Extreme Sales and Rental
Babel Fish Temporary Mid-Probe Centralizer Change
Revision 1

Date: May 10, 2024
Applicability: Babel Fish
Issued By: Jack Rader
InTouch:

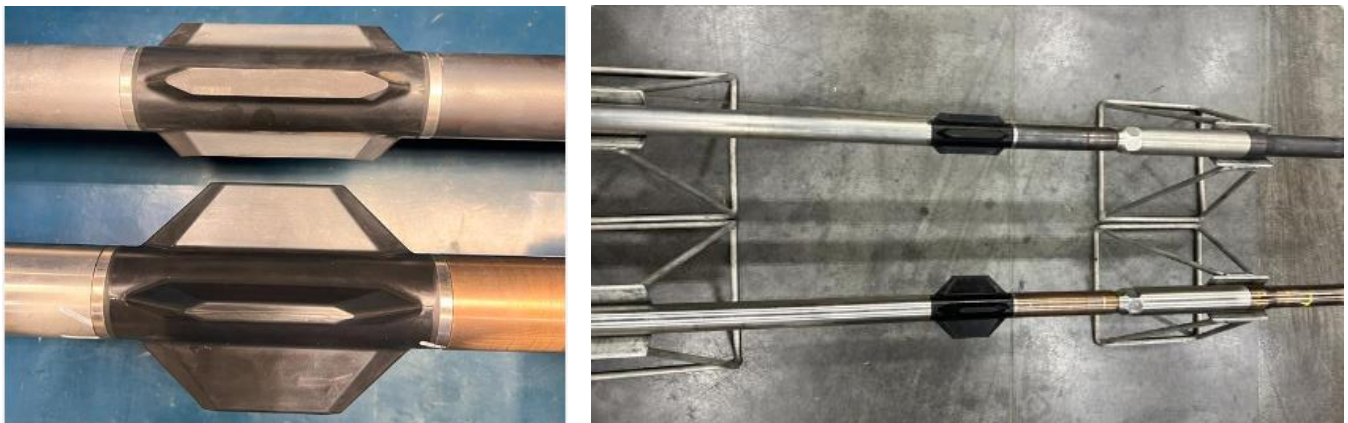
Due to a change in our remolding process mid-probe centralizers measuring 2.815" will be distributed during the transition. The location is highlighted below.

The 2.815" size mid-probe centralizer was run successfully for several years before an update was made to increase the size to allow it to be custom cut to fit the ID of the collar. This was done to in an attempt to reduced shock and vibration across the antenna.

Below are examples of a full size vs reduced sized centralizer.

This is a temporary distribution that will be reverted to full size centralizers when as soon as possible. Until then, the smaller size does not require trimming in most circumstances and is appropriate for use in collar sizes 2.815" and above.
